## ADDENDUM #2

### RSU #57 – DESIGN-BUILD MODULAR CLASSROOM BUILDING PROJECT

86 West Road, Waterboro, Maine

23 February 2024

S:\17-003 RSU #57\Drawings\Massabesic High School\Portable Classroom\17-003 MHS Portables Base.dwg

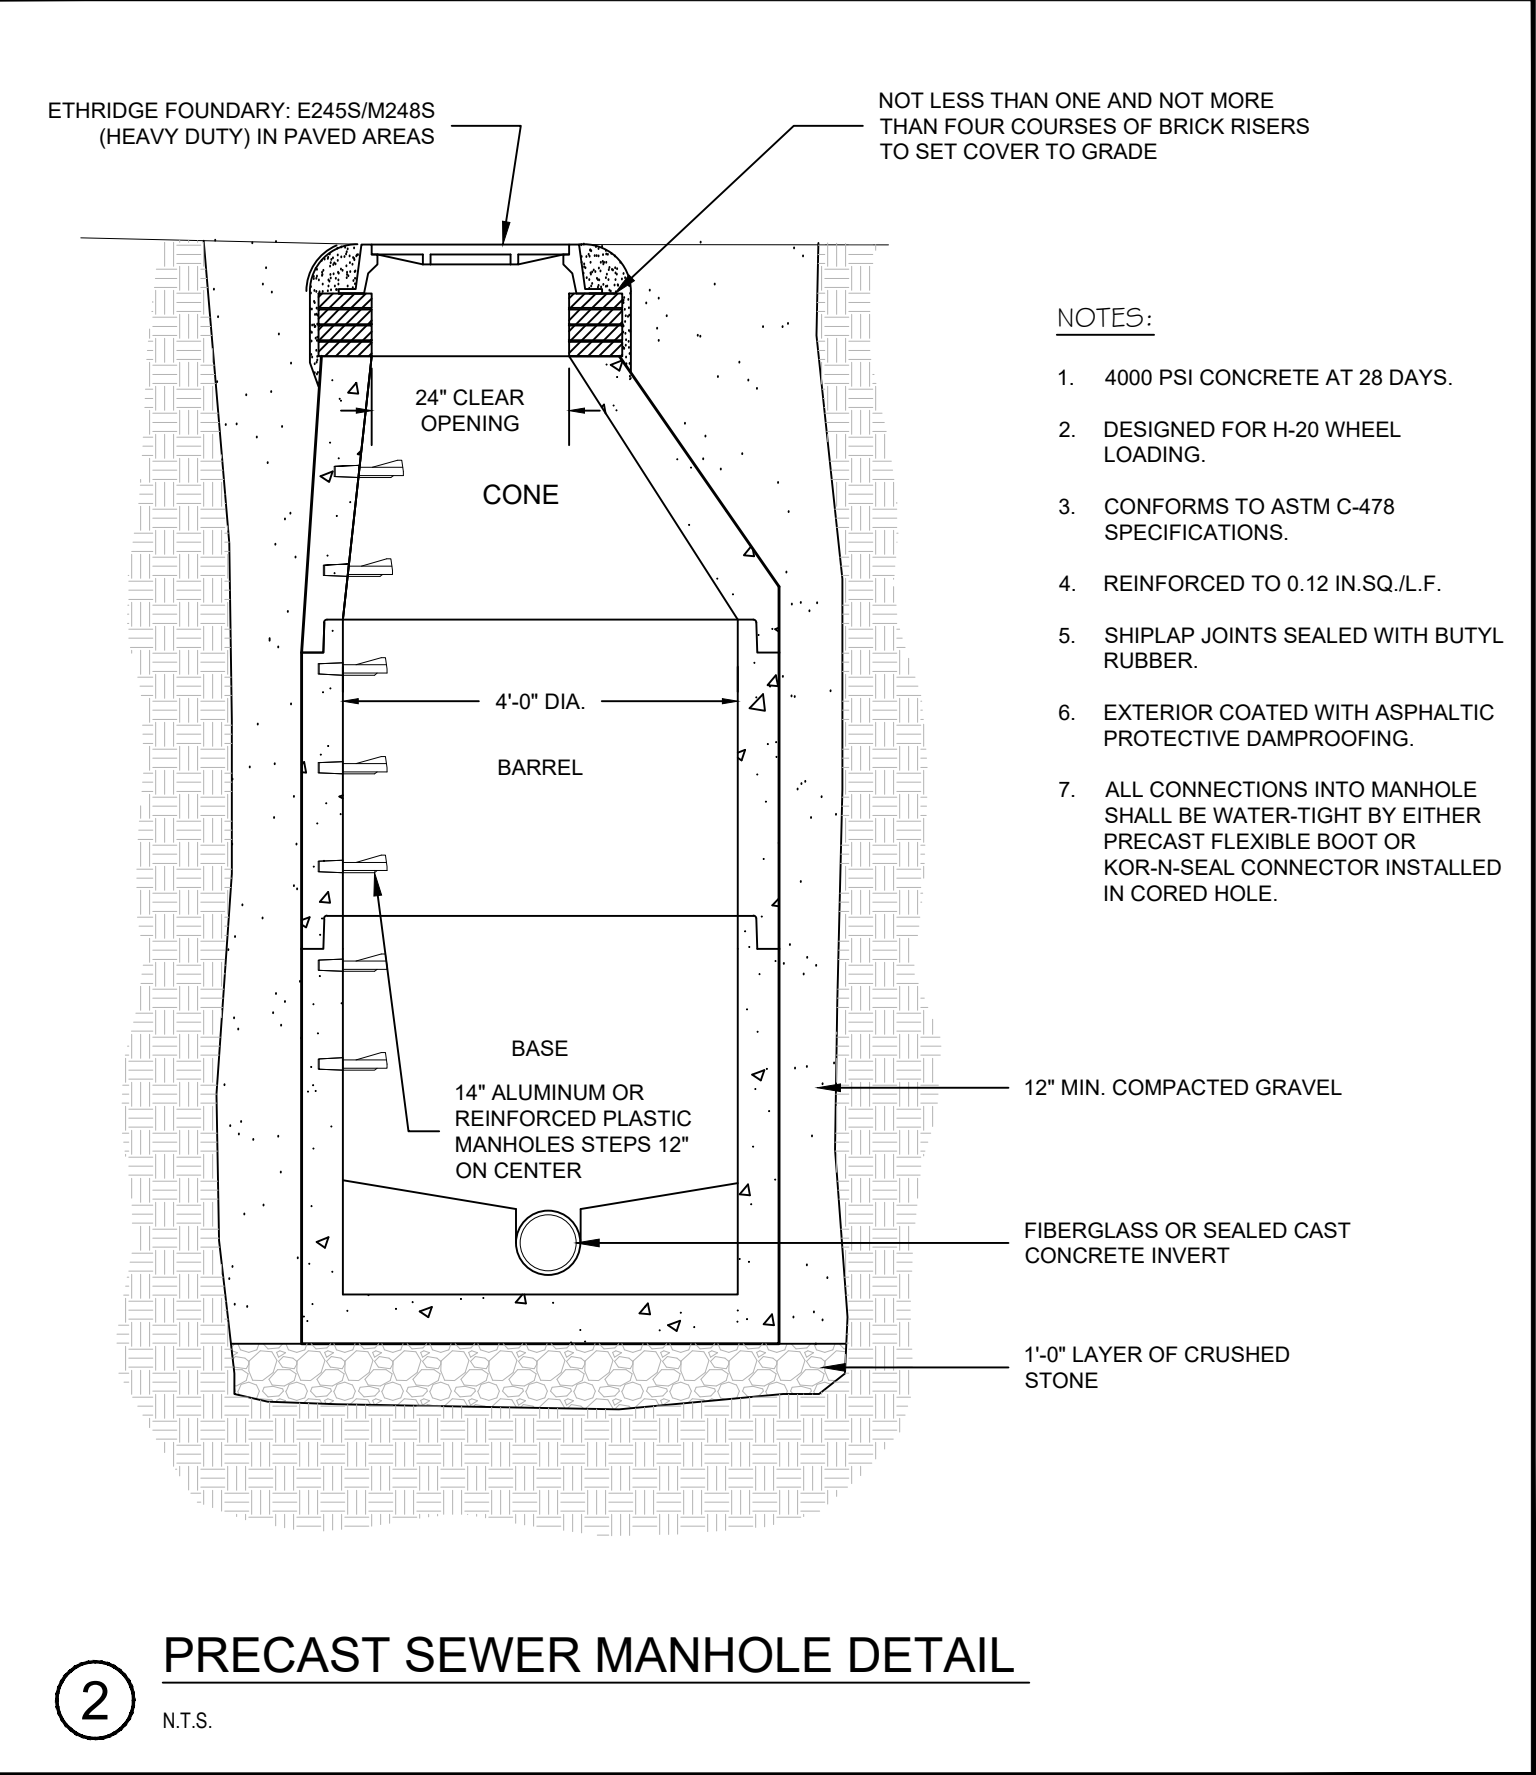
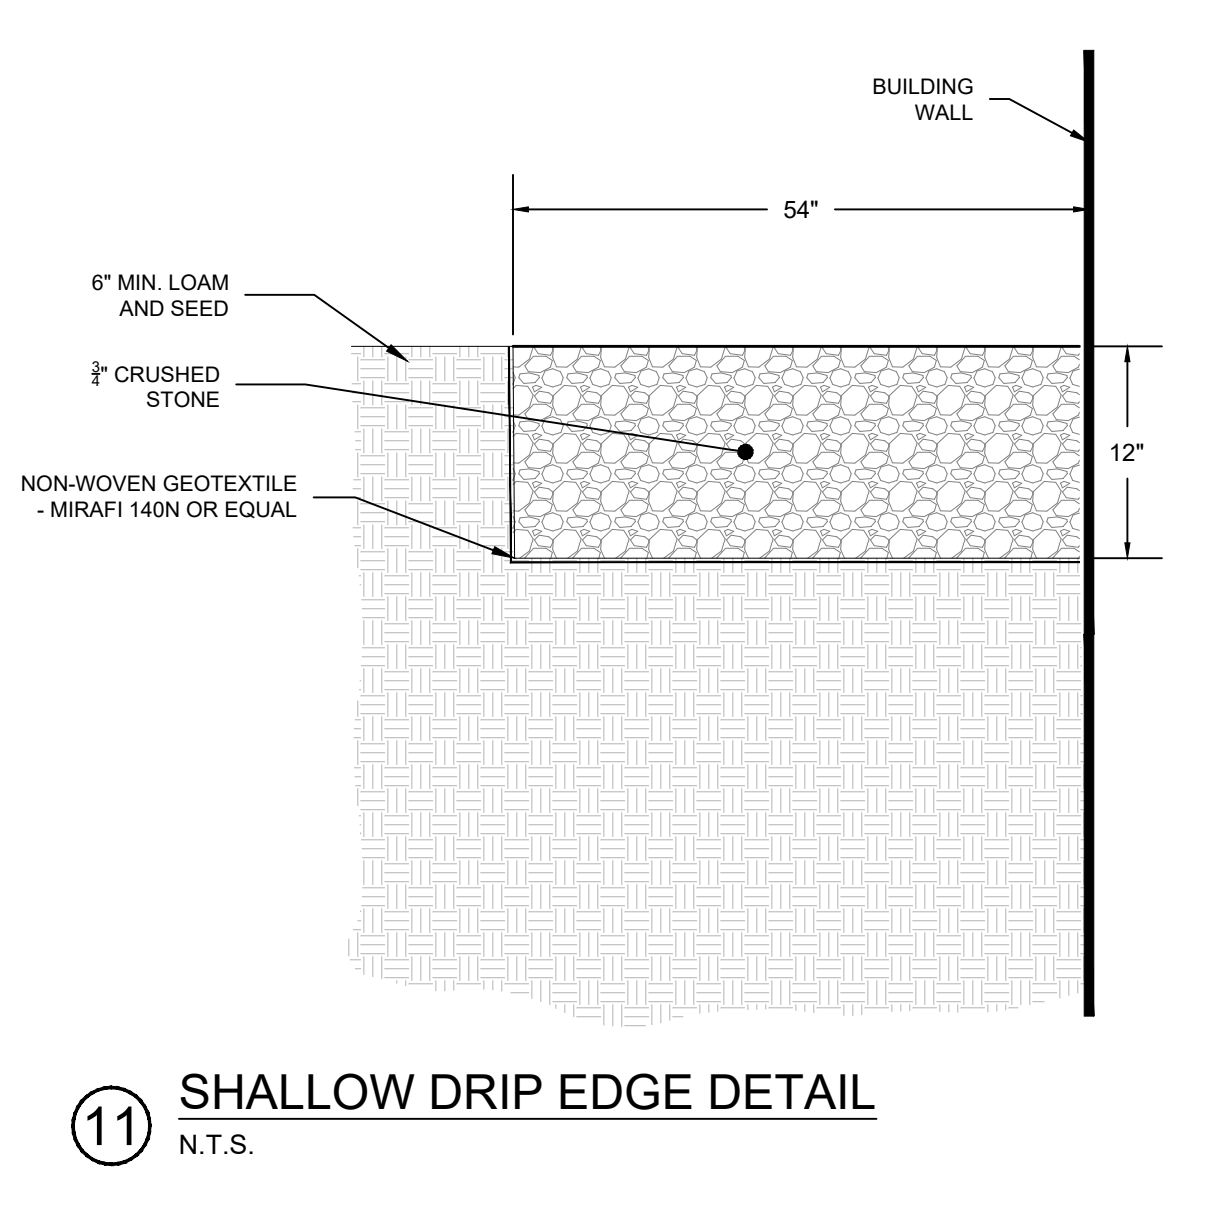
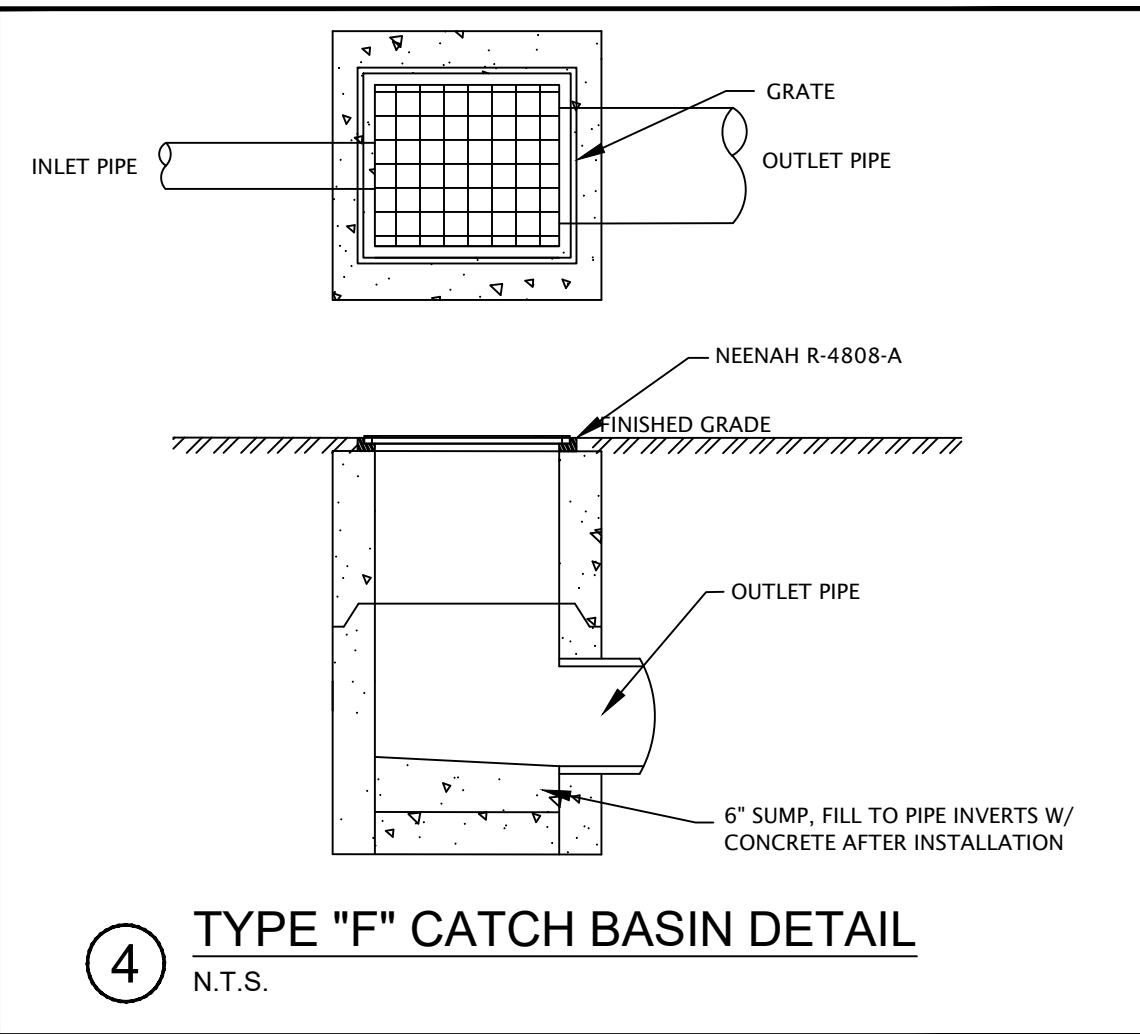
1. Delete drawing C-101A, Portable Classroom Context Plan; and insert the attached revised drawing C-101A, Portable Classroom Context Plan; changes include a revision to the Project Area limit of work.
2. Delete drawing C-101B, Portable Classroom Site Plan; and insert the attached revised drawing C-101B, Portable Classroom Site Plan; changes include revisions to show an underground communications pathway and the new sewer manhole is changed to a septic tank.
3. Delete drawing C-301, Portable Classroom Site Civil Details; and insert the attached revised drawing C-301, Portable Classroom Site Civil Details; changes include the addition of a precast septic tank detail.
